APPLICATION NO.	FILING DATE	FIRST NAMED INVENTOR	ATTORNEY DOCKET NO.	CONFIRMATION NO.
10/055,637	01/23/2002	Stephen L. Siegler	LAWR0021US	9426
24235	7590	07/05/2005	EXAMINER	
LEVINE & MANDELBAUM 444 MADISON AVENUE 35TH FLOOR NEW YORK, NY 10022			FERGUSON, MICHAEL P	
			ART UNIT	PAPER NUMBER
			3679

Office Action Summary	Application No. 10/055,637	Applicant(s) SIEGLER ET AL.	
	Examiner Michael P. Ferguson	Art Unit 3679

DETAILED ACTION

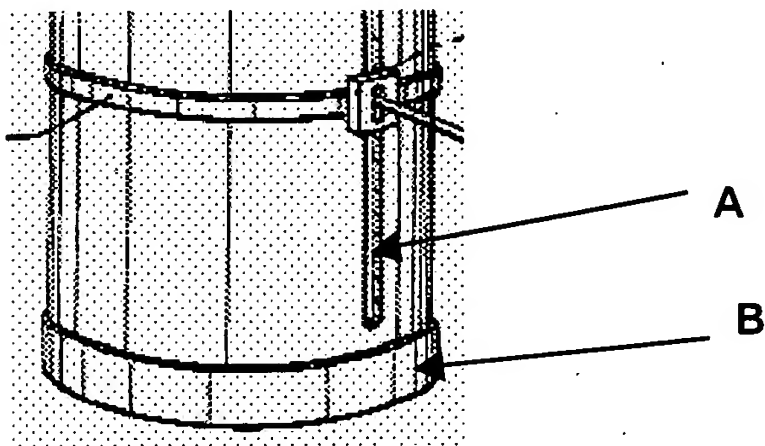
As to claim 1, Payne discloses a pedestrian traffic control device, comprising:
a hollow, upright, one piece, post **4** having an open upper end and a lower end,
a slot **A** (Figure 2 reprinted below with annotations) in the post between its ends,
the slot being spaced from both ends of the post,

a cassette **15,16** located within the post and between its ends, the cassette incorporating a tape **16** wound on a spool **15**, the tape being extendible from the cassette, through the slot the post, in a direction generally perpendicular to the axis of the post, both the upper and lower edges of the tape, when extended, being spaced from the upper end of the post several inches (inherently; based on scale of Figures 1 and 2), and

means **9** for holding the cassette within the post (Figures 2 and 5).

As to claim 4, Payne discloses a device including means **B,13** for supporting the cassette **15,16** within the post **4** in the region of the slot **A** in the post (Figures 2 and 5).

As to claim 5, Payne discloses a device wherein the support means **B,13** includes a tube **B** (identical to upper tube **9**; Figure 6) within the post having an upper end in the region of the lower end of the slot **A** in the post **4**, the cassette **15,16** being seated upon the upper end of the tube (Figures 2 and 6).
